Proposed Revisions to a Standard Plans Index

Date: June 15, 2021 Originator: James McGinnis Phone: (850) 414-4952 Email: james.mcginnis@dot.state.fl.us **Summary of the changes:** Index Number: 102-615 Sheet Number (s): 1 and 4 of 5 Index Title: Multilane Roadway, Intersection Work

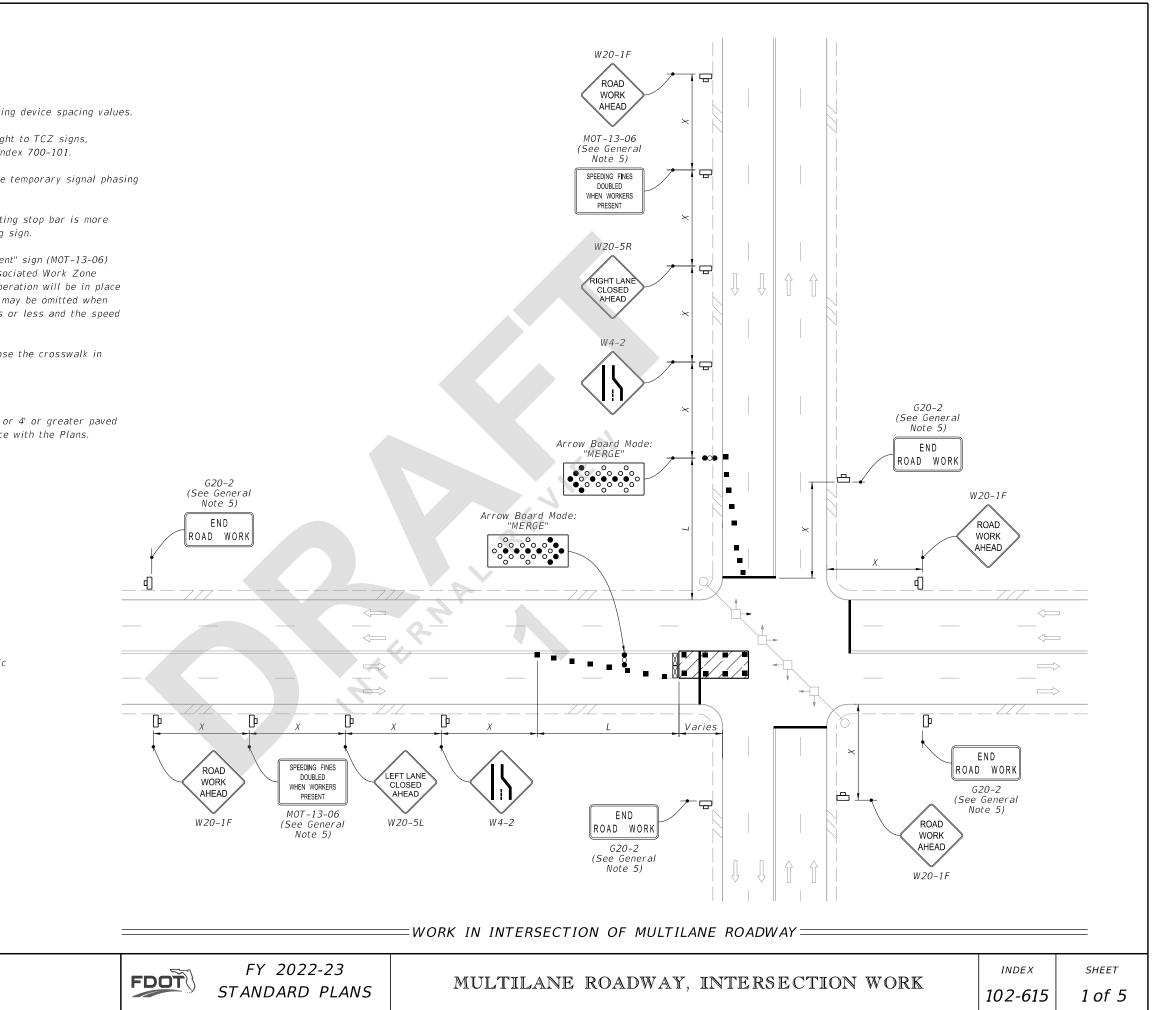
- Sheet 1: Changed Note 5 "work zone" to "work operation"; Changed Note 8 "ridable shoulder" to "4' or greater paved Shoulder".
- Sheet 4: Moved buffer zone and the associated dimension"B" before the Truck Mounted Attenuator in the work zone.

The duration provisions of the index are intended to apply to the length time needed to perform the specific temporary traffic control work "operation" shown, which is independent of the duration of an overall construction project. The term "Work Zone" is being replaced with "Work Operation" to clarify the intent.

- 5. The "Speeding Fines Doubled When Workers Present" sign (MOT-13-06) and "End Road Work" Sign (G20-2), along with associated Work Zone Sign Distances, may be omitted when the work operation will be in place for 24 hours or less. Additionally, arrow boards may be omitted when the work operation will be in place for 60 minutes or less and the speed limit is 45 mph or less.

- 8. If the work encroaches on a marked bicycle lane or 4' or greater paved shoulder, close the lane or shoulder in accordance with the Plans.

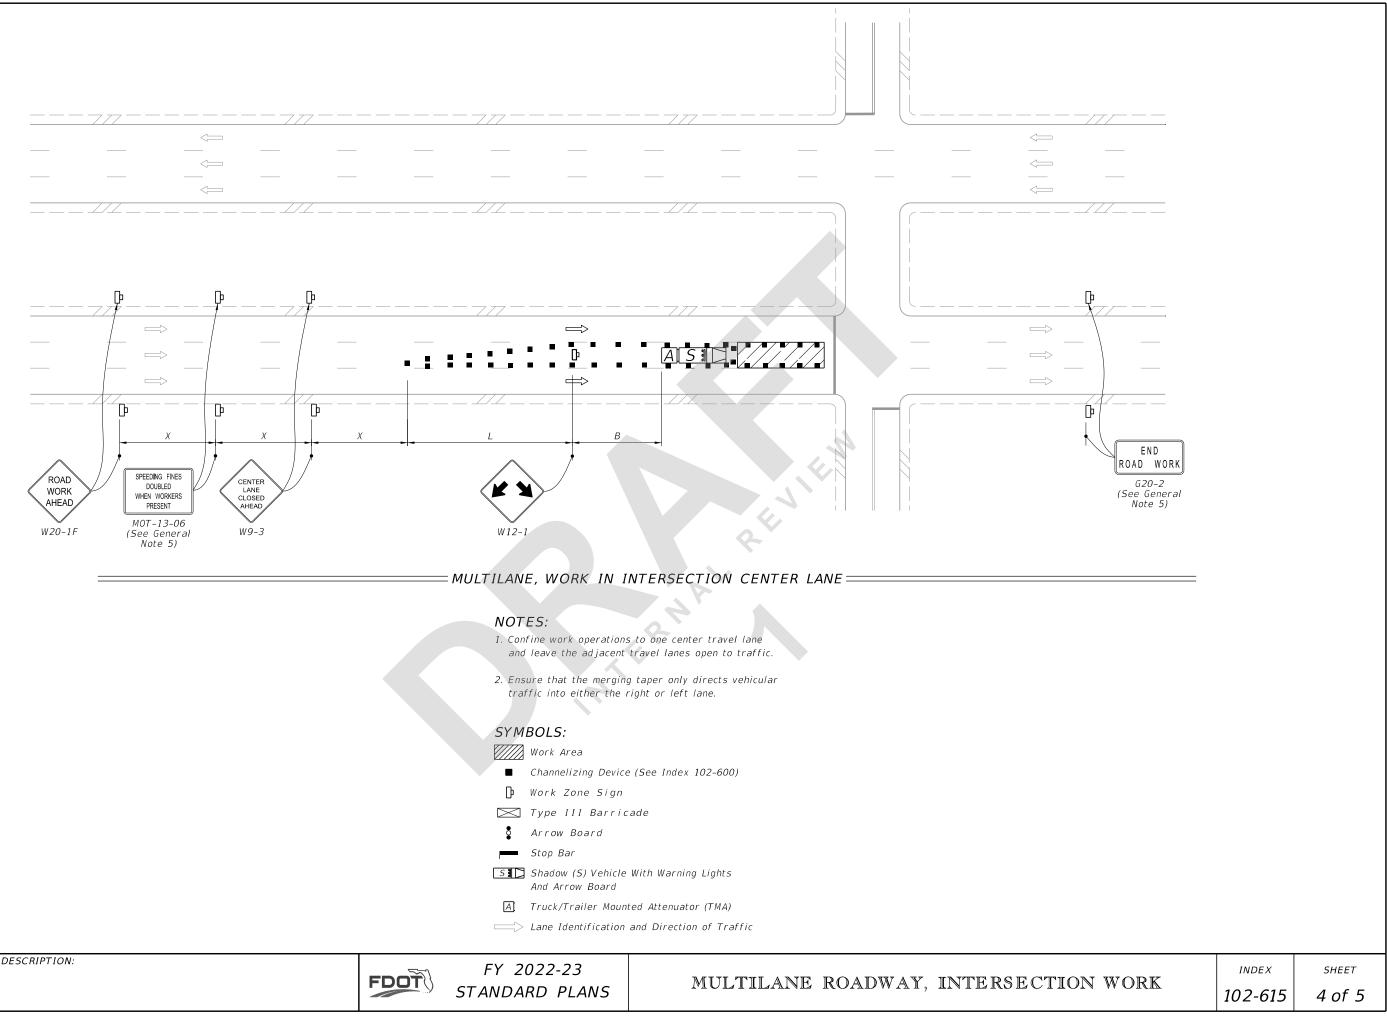
The buffer space was moved to be consistent with the MUTCD. MUTCD guidance says "When a shadow vehicle, arrow board, or changeable message sign is placed in a closed lane in advance of a work space, only the area upstream of the vehicle, arrow board, or changeable message sign constitutes the buffer space."
